ACCESSION NBR: 8309080152 DOC. DATE: 83/08/30 NOTARIZED: NO DOCKET #
 FACIL: 50-275 Diablo Canyon Nuclear Power Plant, Unit 1, Pacific Gas 05000275
 AUTH. NAME: AUTHOR AFFILIATION
 SCHUYLER, J.O. Pacific Gas & Electric Co.
 RECIP. NAME: RECIPIENT AFFILIATION
 EISENHUT, D.G. Division of Licensing

SUBJECT: Forwards responses to unresolved items identified in SSER
 18. Seismic analyses of auxiliary bldg using stick models
 consistant w/FSAR & Hqsari rept.

Re: Docket No. 50-275, OL-DPR-76
Diablo Canyon Unit 1
Safety Evaluation Report, Supplement No. 18

ENCLOSURE 1
SAFETY EVALUATION REPORT
SUPPLEMENT NO. 18
POTENTIAL UNRESOLVED ITEMS

FIGURE 1

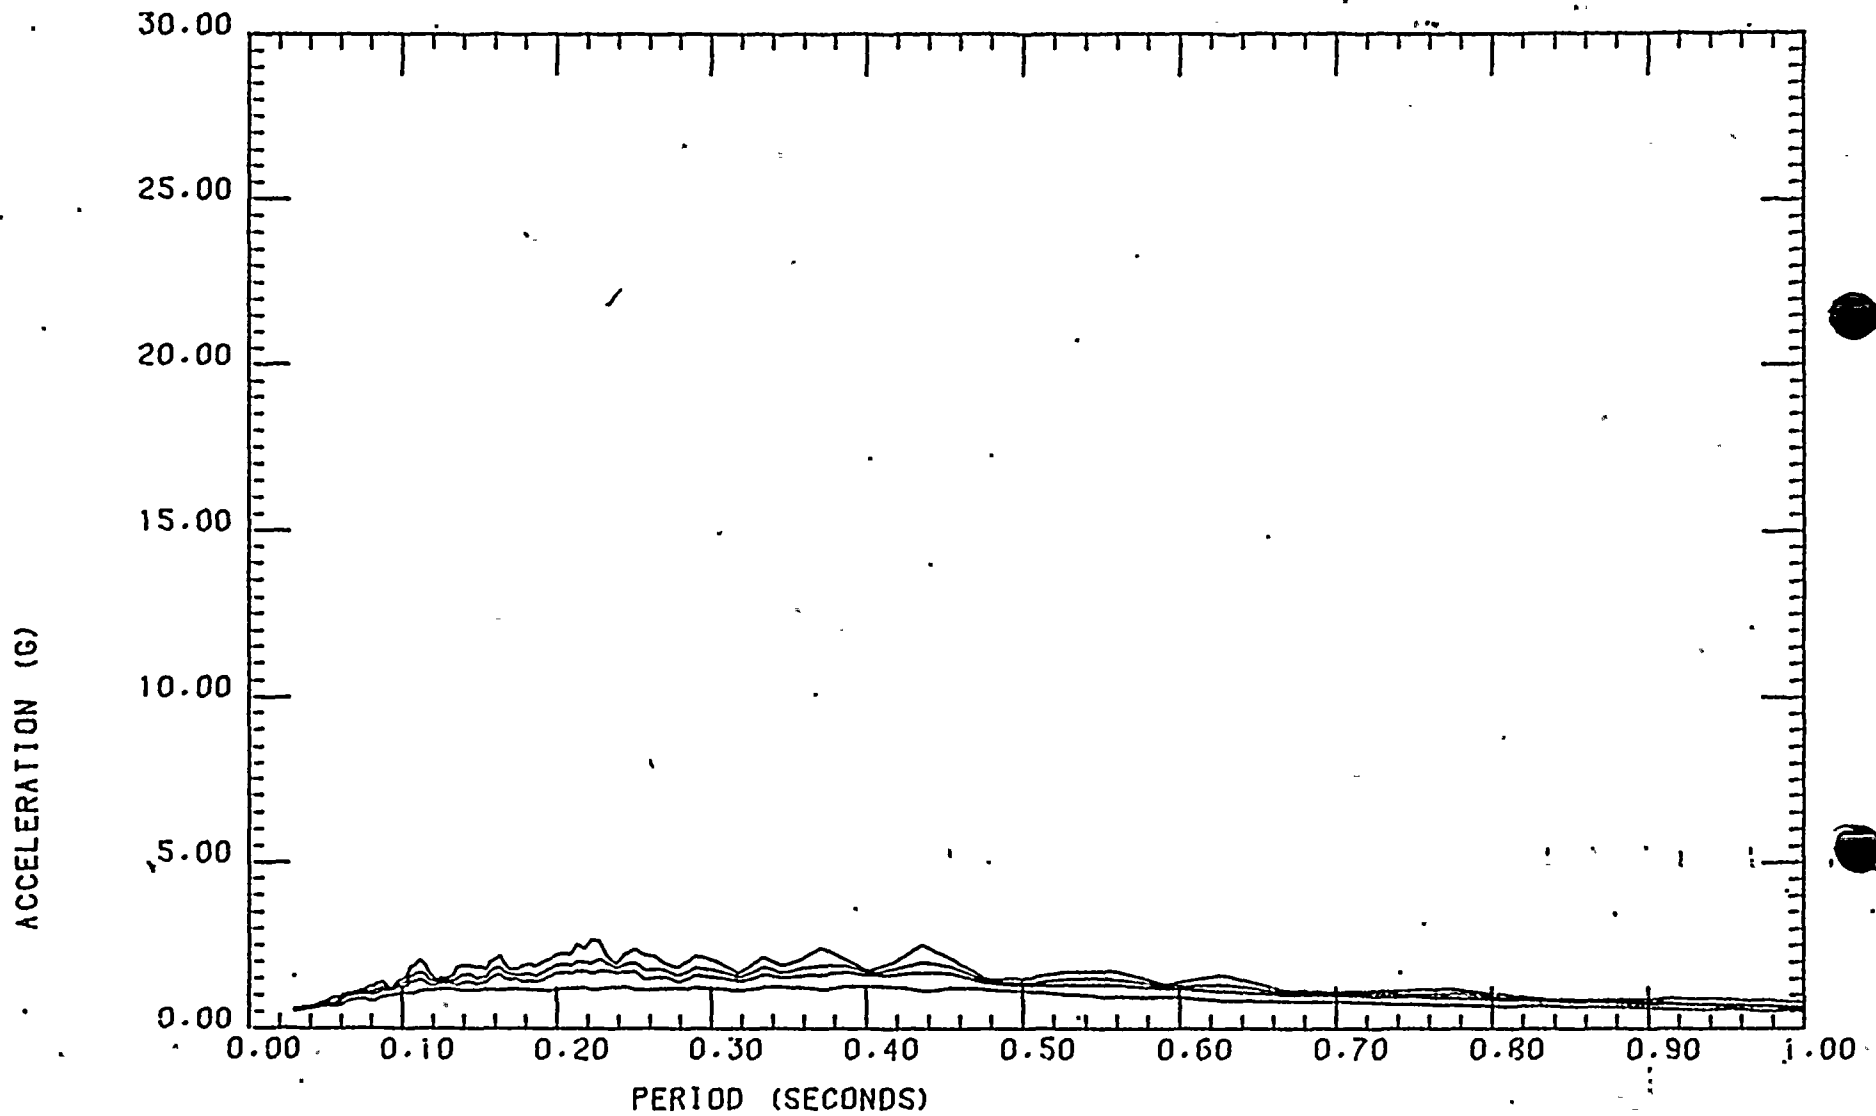
"The reason for using four separate vertical models for the turbine building is based on the fact that the large openings in the floors at the turbine pedestal divide the floors into separate areas. However, the effect of the continuous exterior wall that connects to all the floors was not investigated. This could affect the final results."

It should be noted that the exterior walls extend from column lines 5.7 to 16 which is the area represented by models 2 and 3. Furthermore, the exterior walls in model 3 extend for one bay and go up to elevation 104 ft only. Hence there is no coupling between vertical models 1 and 2, and the coupling between vertical models 2 and 3 due to the exterior walls is not considered to be significant.

In addition to the limited wall area that extends from model 2 to model 3, the exterior walls are stiff in their own plane and do not significantly amplify the ground motion. This can be seen by comparing the attached representative response spectra. Figure 1 shows the input ground response spectra. Figure 2 is the floor response spectra at column line A, bent 9 and elevation 140 ft. Figure 3 is the floor response spectra at column line G, bent 6.6 and elevation 140 ft. Comparison of the three spectra confirms that there is no significant amplification of ground motion through the wall.
